SUBJECT: PLANS AND PROPOSAL ADDENDUMS
PROJECT: STP 2023 (675)MM CONTROL: 1433-02-044
COUNTY: COMAL
LETTING: 05/04/2023
REFERENCE NO: 0419

PROPOSAL ADDENDUMS

DESCRIPTION OF ABOVE CHANGES
(INCLUDING PLANS SHEET CHANGES)

NOTE:
 SEE GEOMETRIC DATA SHEETS
 FOR HORIZONTAL ALIGNMENT
 INFORMATION.
 SEE MISCELLANEOUS CURB AND
 SIDEWALK DETAILS FOR
 SIDEWALK AND CURB DETAILS.
 SEE DRIVEWAY DETAILS
 AND SUMMARY SHEETS FOR
 DRIVEWAY DETAILS AND
 QUANTITIES.
 SEE INTERSECTION LAYOUTS FOR
 INTERSECTION DETAILS.

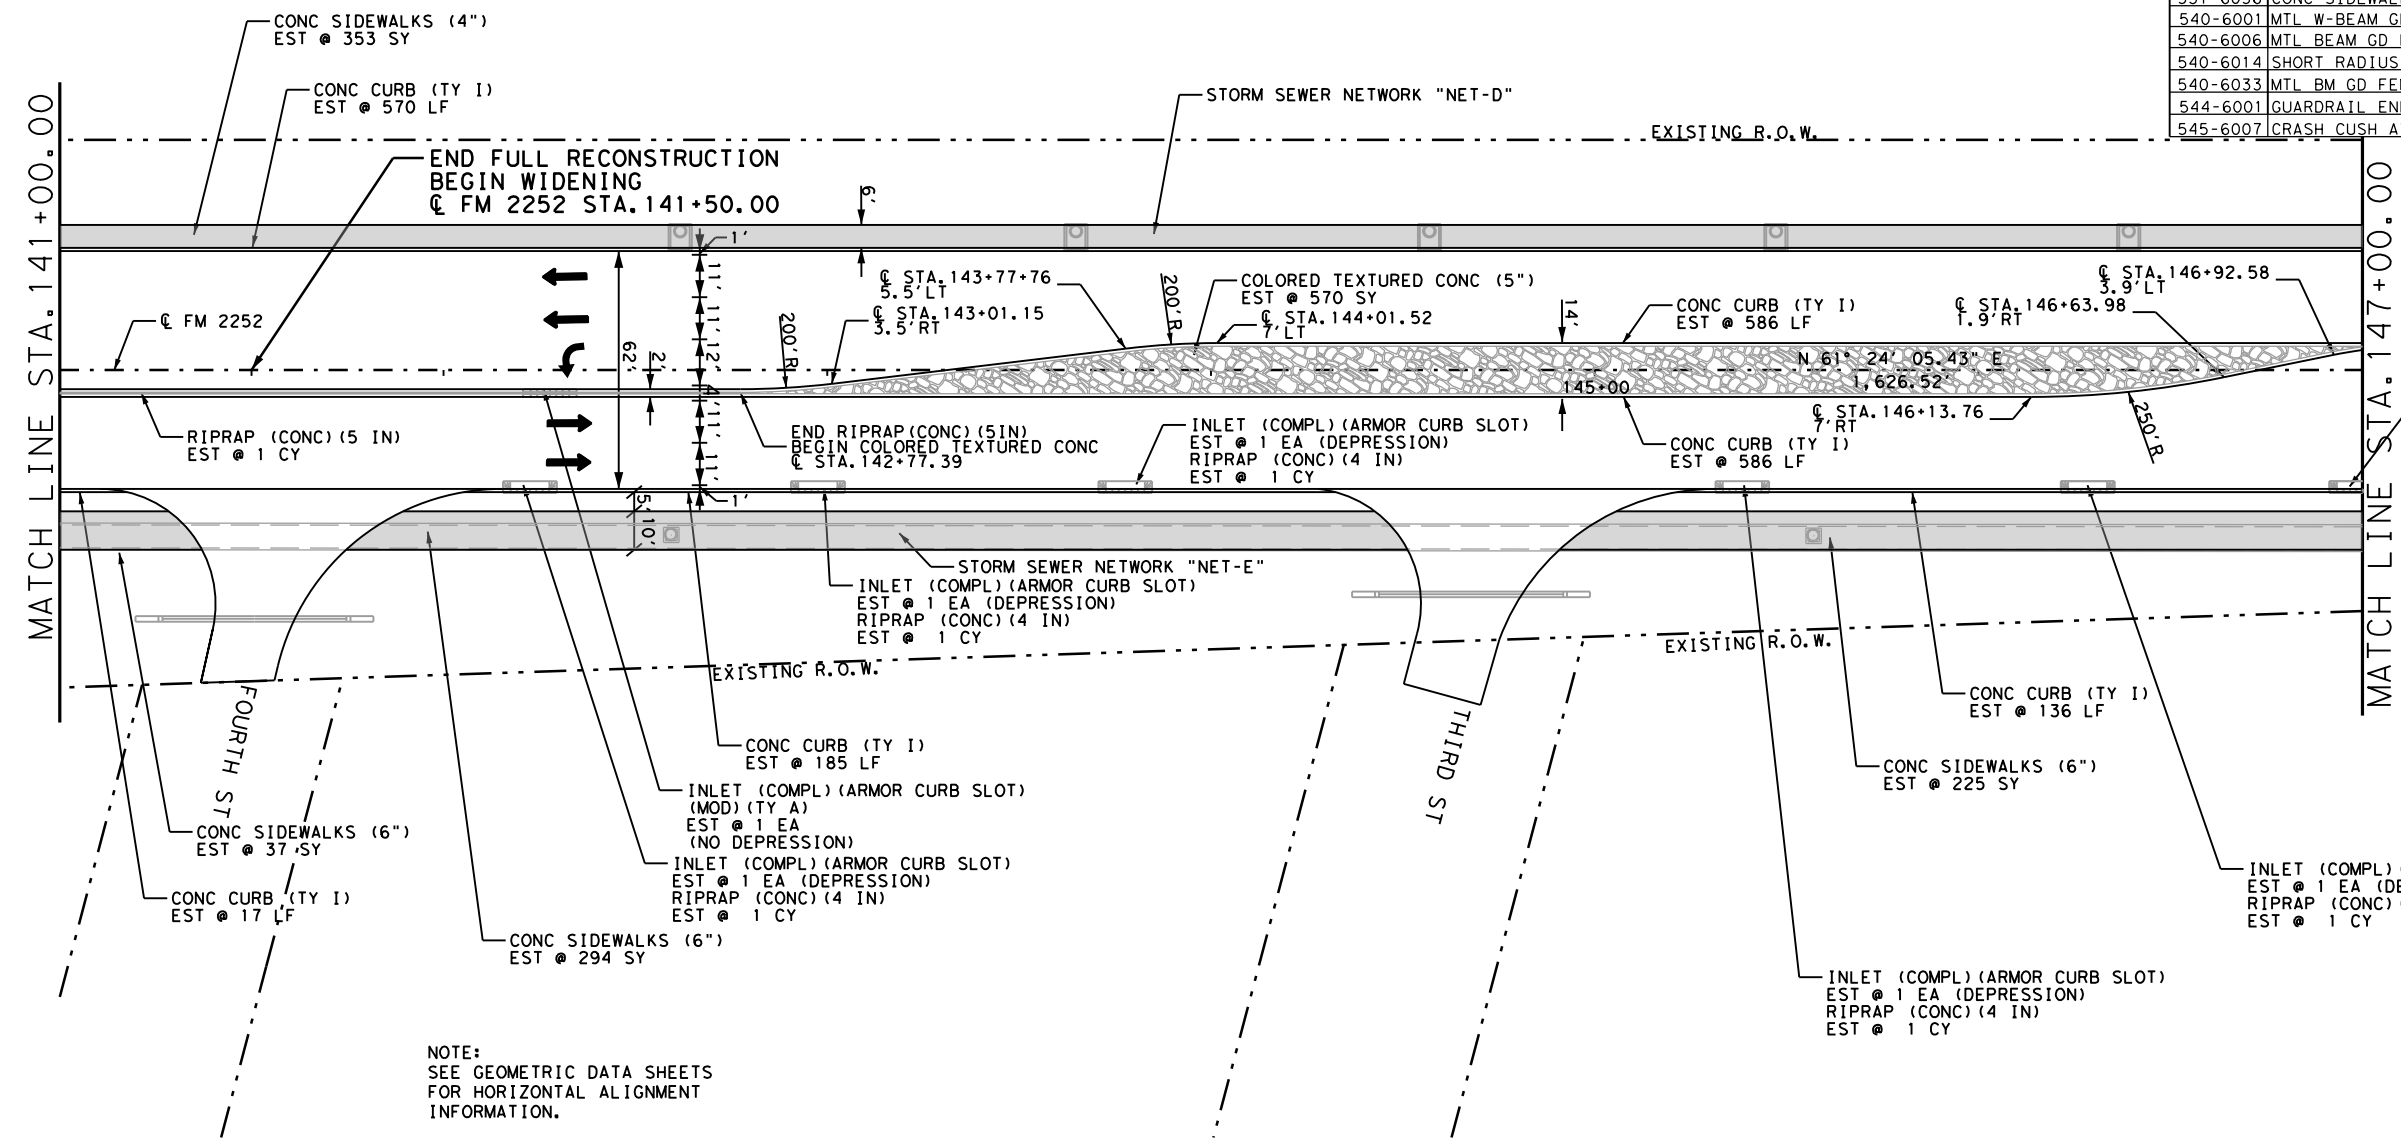
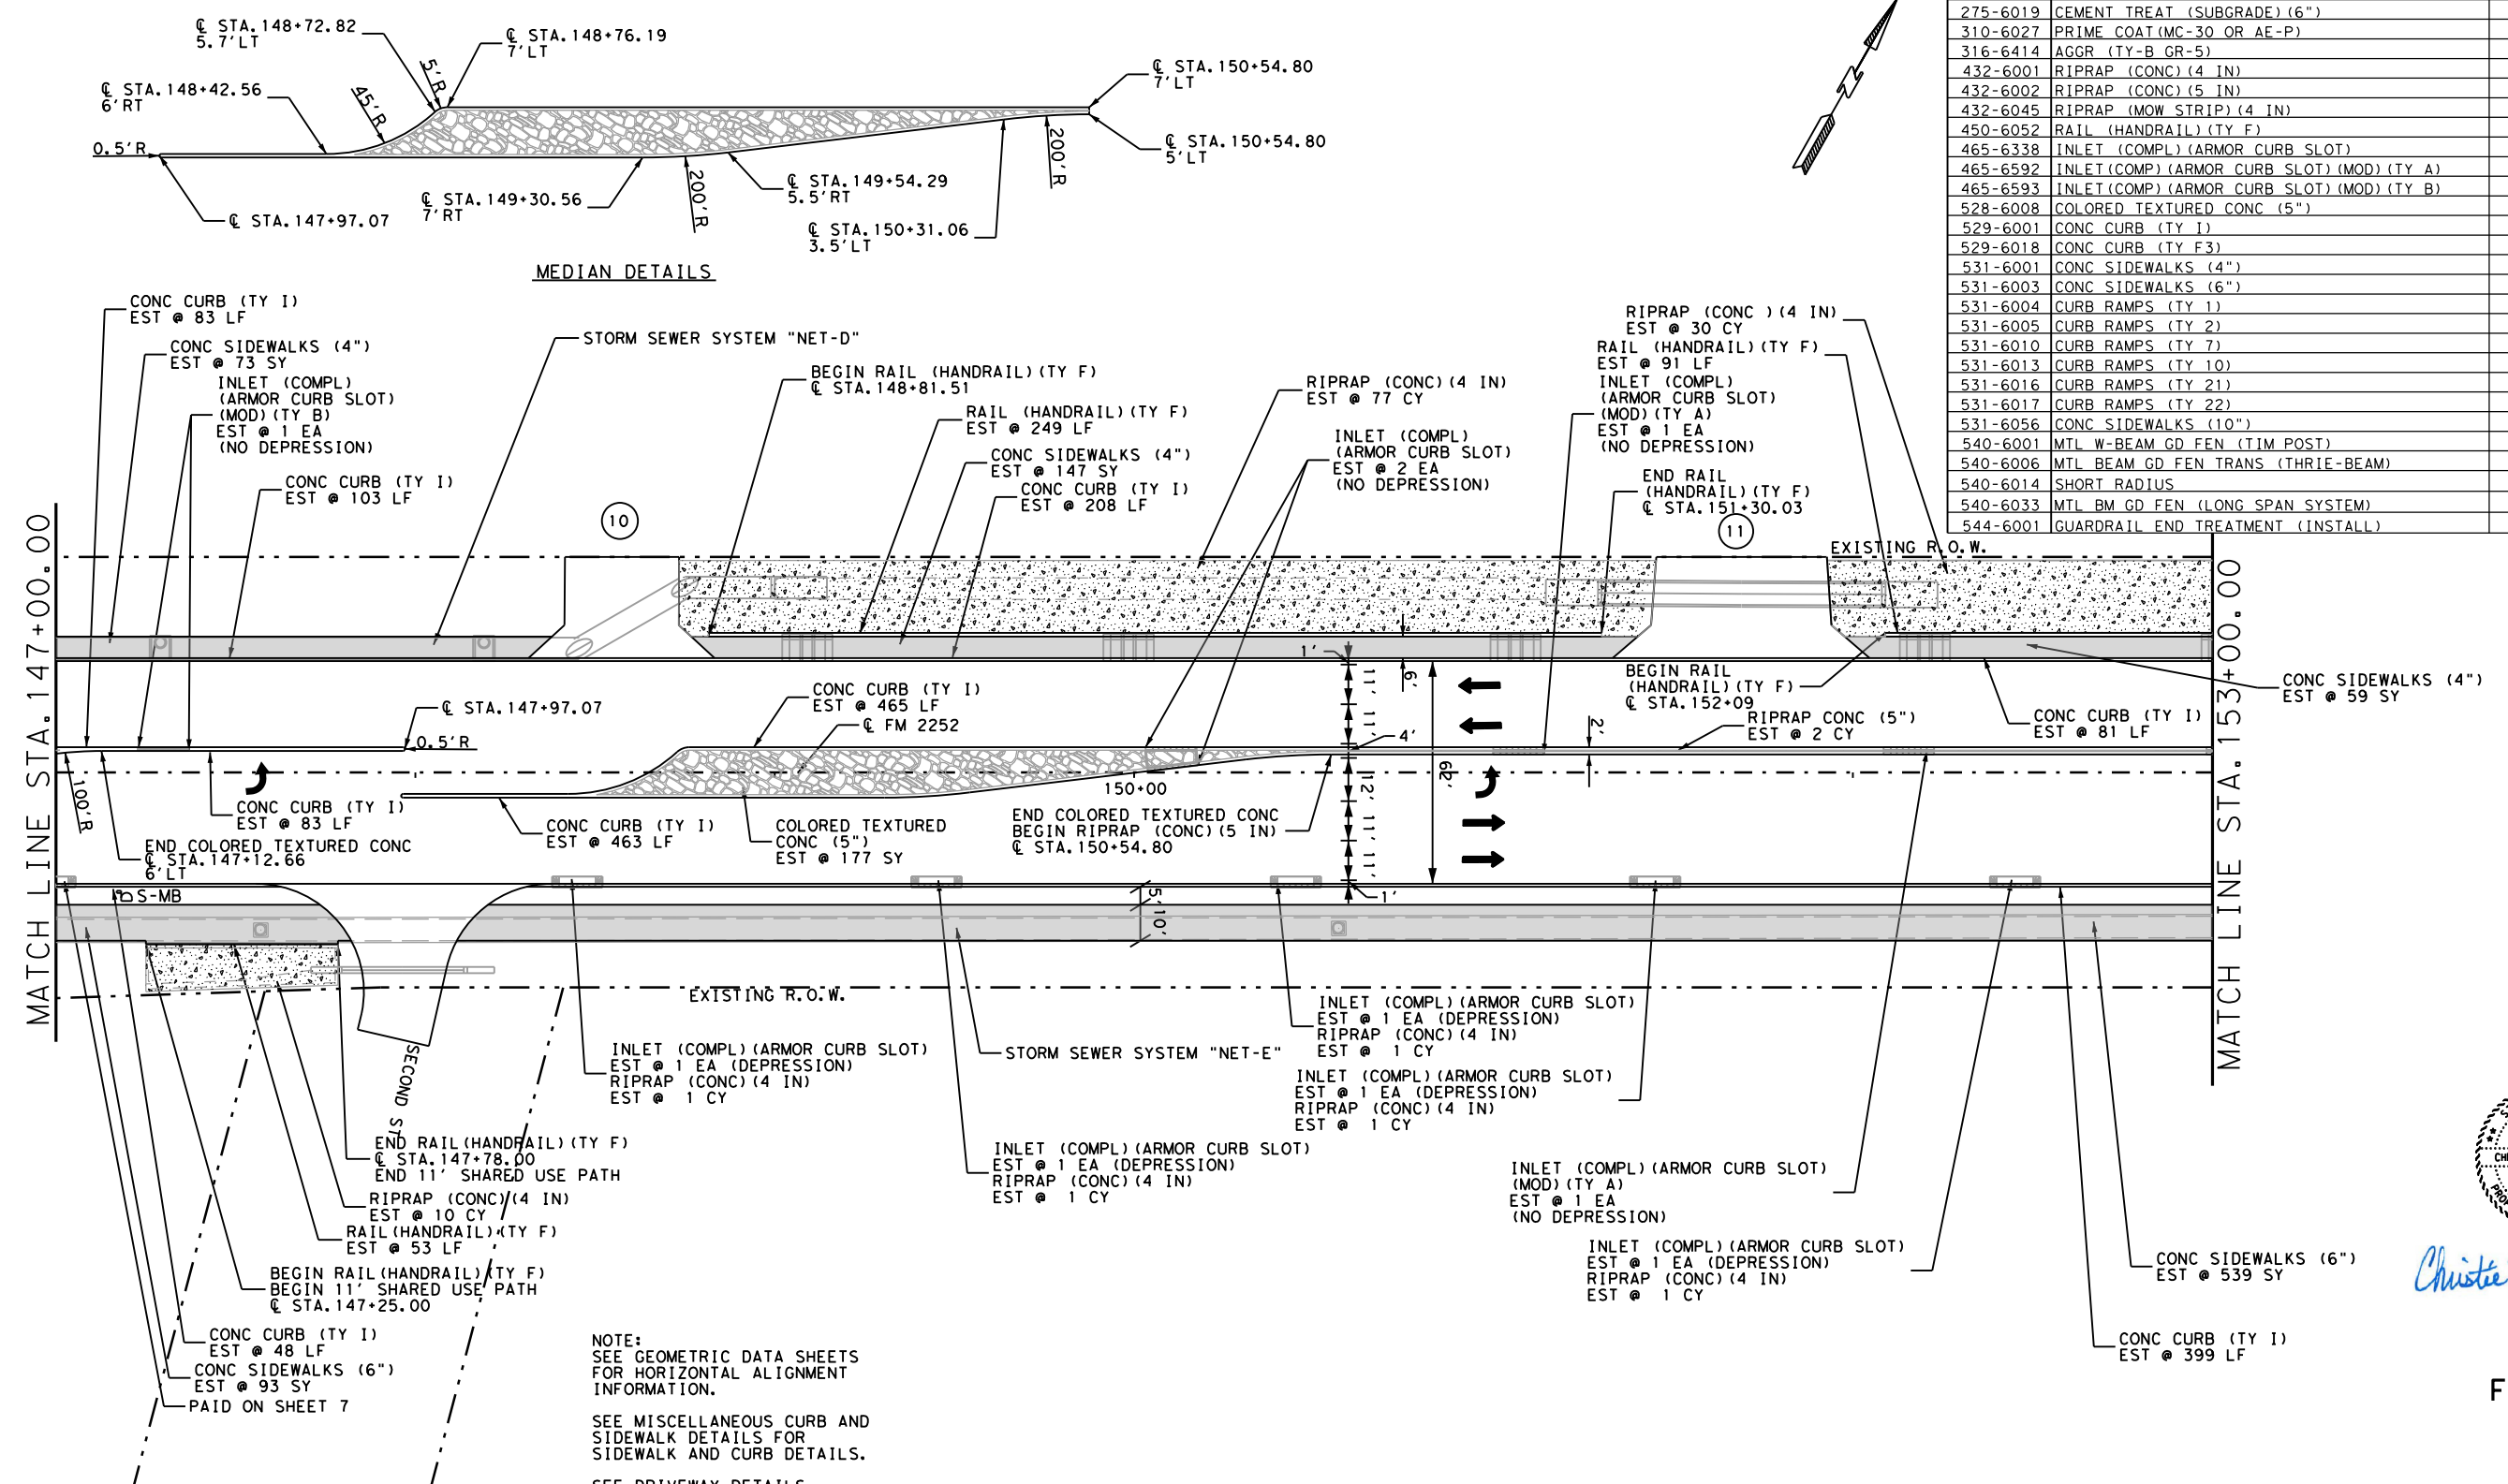
SHEETS 413-449: REPLACED ITEM NO. 545-6017 WITH ITEM NO. 545-6007
